Amendments to the Drawings

Application No. 10/748,755
Amdt. dated December 11, 2006
Reply to Office Action dated August 10, 2006

FIG. 1

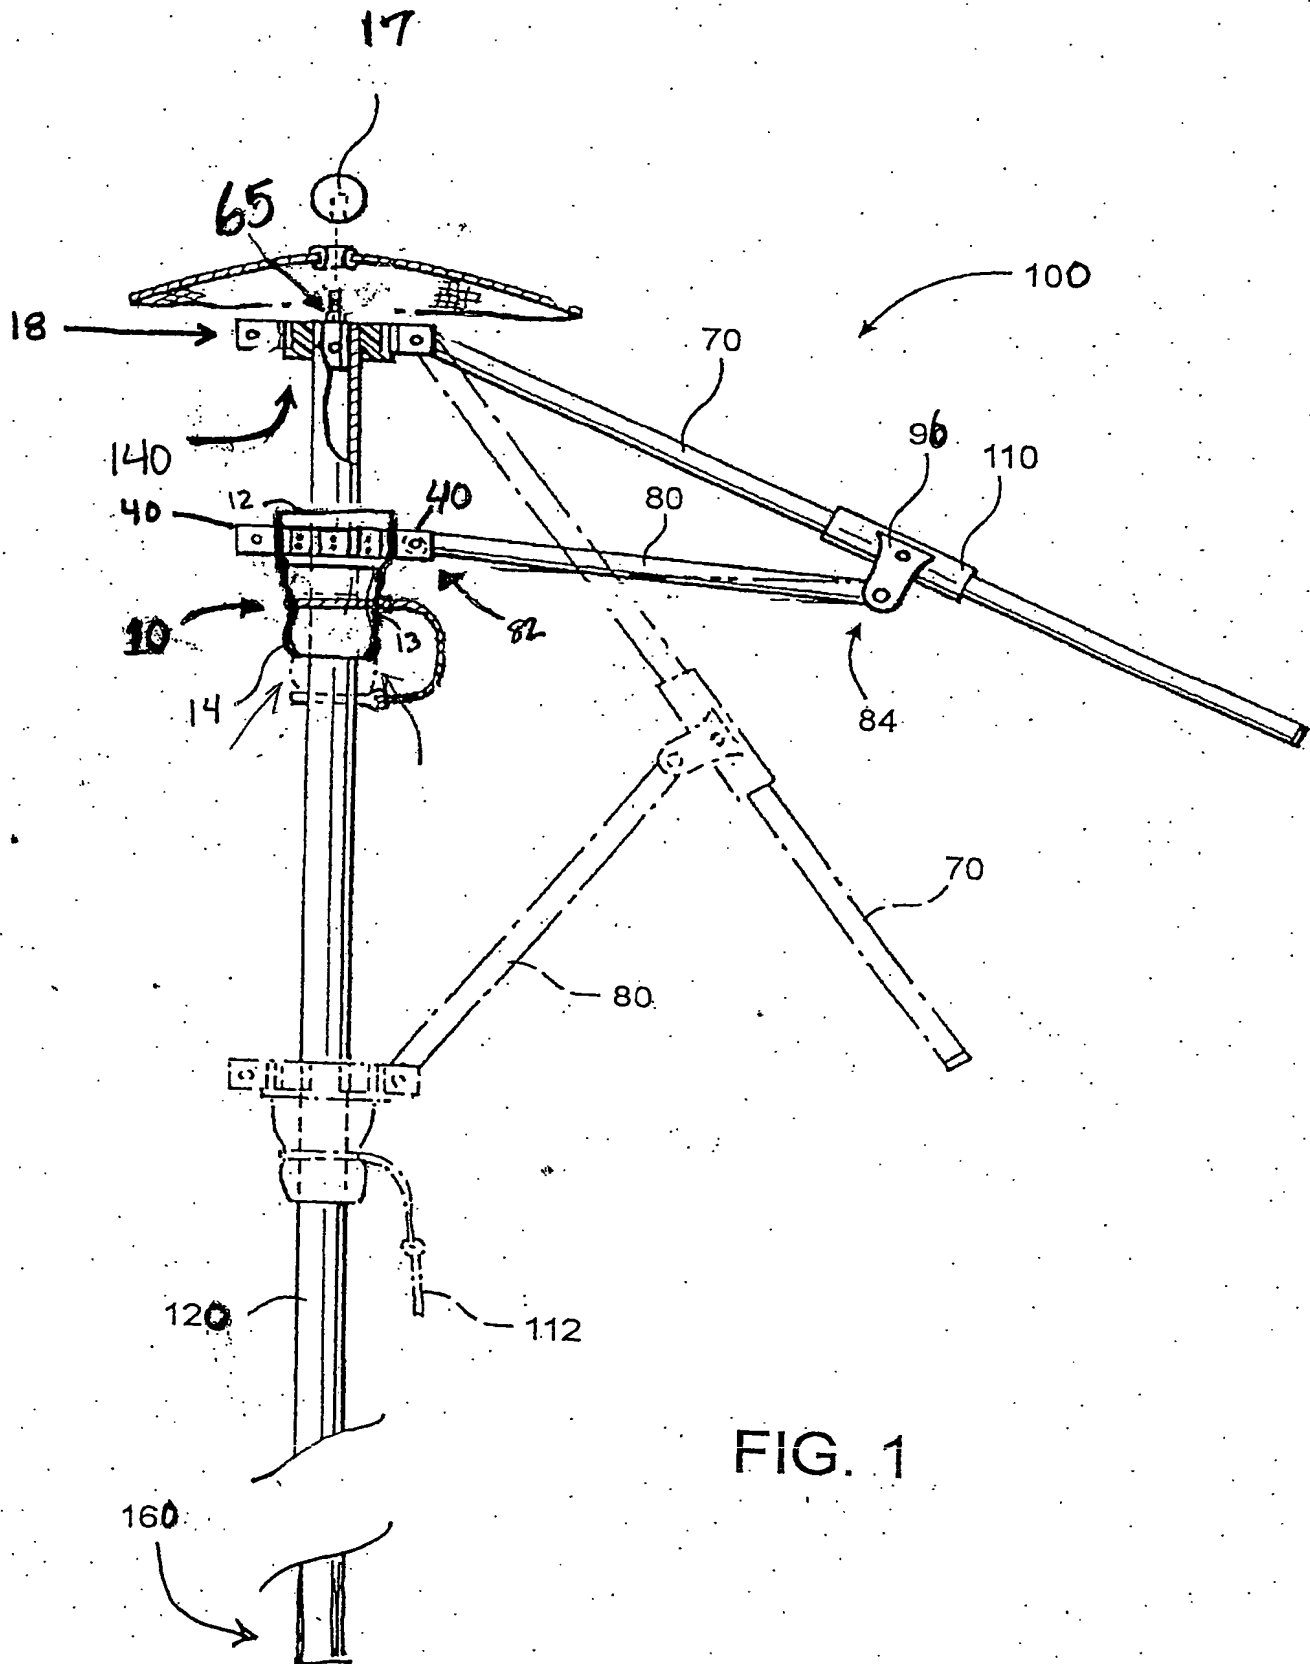
Further, as set forth above, the drawings are objected to as failing to comply with 37 C.F.R. §1.84(m) because the solid black shading is not permitted. Accordingly, six (6) Replacement Sheets are attached hereto which more clearly depict Applicant's novel invention without any solid black shading.
